# Extinguish the Torch Meeting

## Final Summary Report

### **Project: NB Turnpike and Glades Intersection Improvements**

**Financial Project Number: 435615-1/4-52-01**

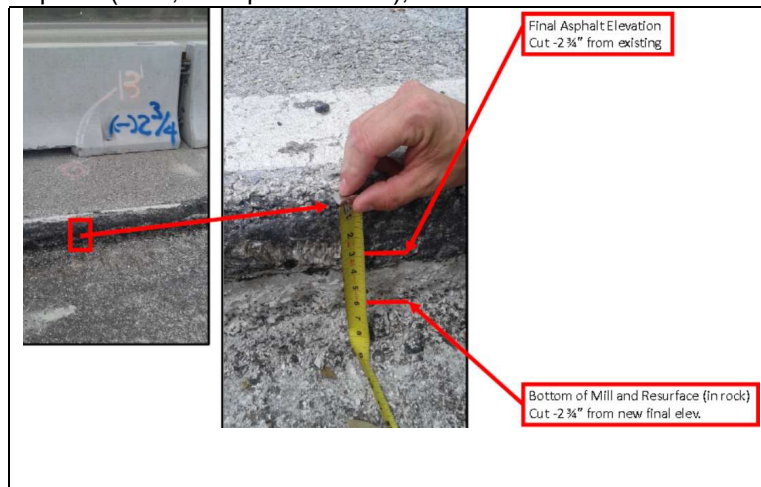
The improvements called for widening on the outside (Phase 1) and inside (Phase 2) of the Turnpike with cross-slope correction and with 1/2" additional milling to gain wall reveal.

The plans did not indicate which phase to complete the Milling & Resurfacing, and called for outside widening first, and then the inside widening, and there was a concern with drop-offs created and the potential for holding water during the M & R operations.

In addition, due to the deep mill (3 1/4", 2 3/4" plus 3/4" FC5), there was a concern about hitting existing base.

Additional pre-pave meetings (workshops) were held early, and supplemental information was provided by the EOR (stations, offsets, elevations). From this information, it was clear that there would be a significant drop-off at the outside widening that would need to be addressed to allow the Phase 2 traffic shift. A sacrificial asphalt wedge was placed on the outside widening to address the drop off.

Additionally, due to the concern with hitting base, that became evident after the pavement was sawcut and removed, the Turnpike Materials office performed pavement coring to verify existing asphalt thickness. Due to the thin asphalt, the EOR modified the cross-slope of R-3 from 2.5% to 2% to address the issue. This adjusted cross-slope resulted in re-paving required on the outside auxiliary lane and the outside shoulder along the mainline between Stations 472+88 to 491+00, that had already been widened and paved during Phase 1B.

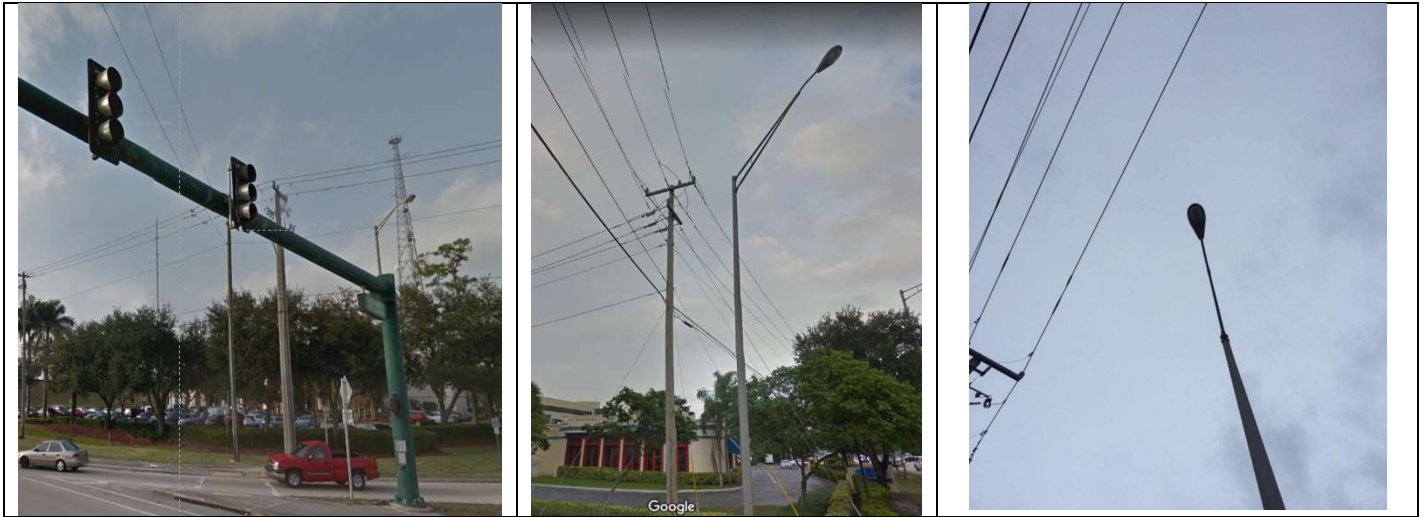
The designer did not include performance turf for areas within the project that should have been included, and the performance turf in these areas and had to be negotiated to close out the project. For example, the LWDD Permit area required 4010 SY of sod for restoration.

The designer should consider how areas are to be accessed for construction, and include additional areas within the performance turf quantity as well, not just the area identified as clearing and grubbing. Maybe a contingent amount can also be included in the quantity.

For the LWDD right of way area, the CEI negotiated with the contractor to pay only for materials (\$1.98 per SY or \$7,940.00), since LWDD allowed excess material to remain within the LWDD R/W, a benefit to the contractor. Other areas requiring restoration were negotiated, in a similar manner. **Total additional costs related to performance turf totaled \$15,000.**

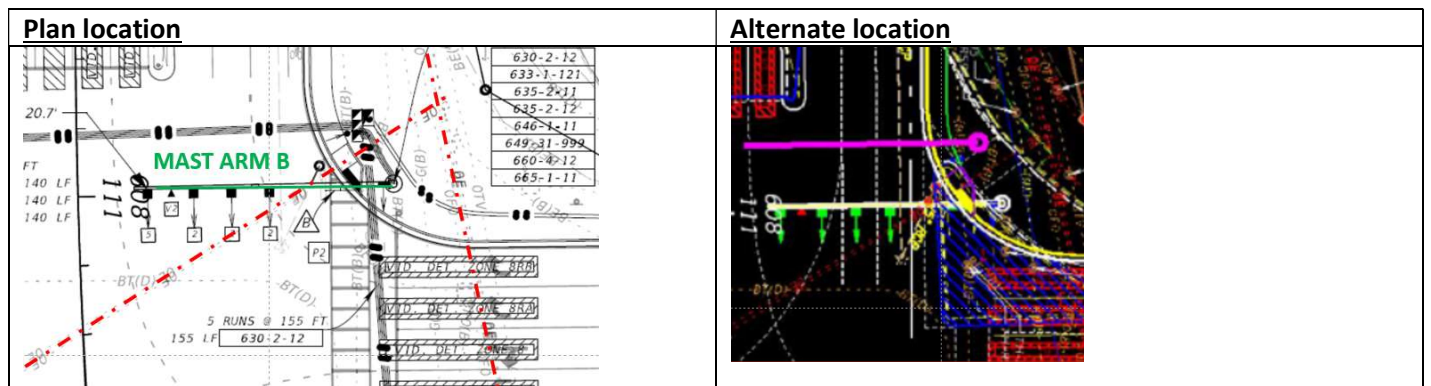
There were conflicts with overhead electric that had to be addressed during construction. The installation of the Mast Arm B on the NW corner of Turnpike entrance and Glades and the removal of the existing signal arm, and the removal

of 2 existing light poles on the NE and NW corners. The UWS did not include de-energizing (per the EOR, the 10' OSHA clearance was met). However, the contractor indicated the OSHA clearance could not be met, and this was confirmed in the field.

The proposed location of the mast arm was modified to minimize the OE conflict with the line running along Glades. In addition, an arrangement was made with FPL to de-energize the overhead electric running across the intersection, as this OE was only for the signal. One de-energizing was accomplished by FPL concurrently with a pole hold that was part of the UWS. In addition, FPL agreed to provide a 2-hour outage of the single-phase OE running parallel to Glades to allow for the removal of the 2 light poles approximately 5' from the OE.

This was accomplished through direct coordination with FPL during construction, and was provided by FPL as a courtesy and partnering effort, at **no additional cost to the Department**.

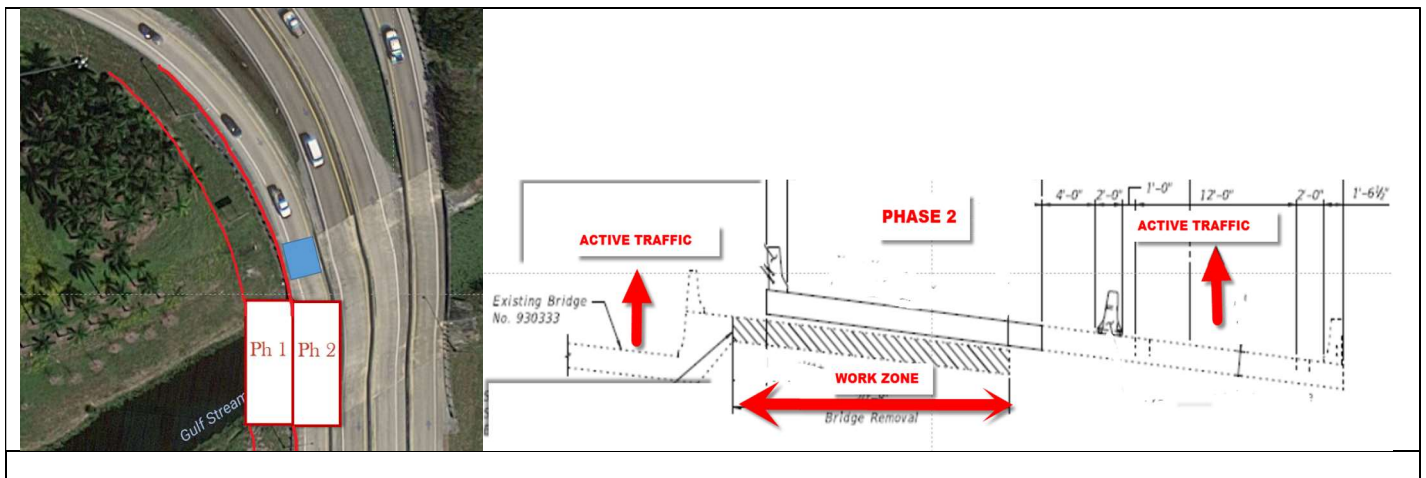
The plans included 284 hours for officers on Glades Road only. No officer hours were included for Turnpike. Officers were required for most of the inside median widening work (Phase 2), and for most Phase 2 Ramp D-1 bridge work.

The lane closure restrictions indicated that a “single lane” closure on the ramp was permitted between 9:00 pm to 6:00 am; however, there was only one lane on the ramp, so each lane closure was a FULL RAMP CLOSURE, requiring detours for each closure and off-duty officers.

ONLY ONE Lane on Ramp - FULL RAMP CLOSURE

Officer hours were overrun, as needed. **Additional cost to the contract: \$58,901.85**

For the Ramp D-1 bridge construction work, the Turnpike allowed a continuous Ramp Full Weekend Closure (10 pm Friday to 5 am Monday) and extended closures on the other weekends to allow the contractor to complete the most time-consuming operations, such as canal excavation and riprap placement with fewer ramp closures and inconvenience to the travelling public.
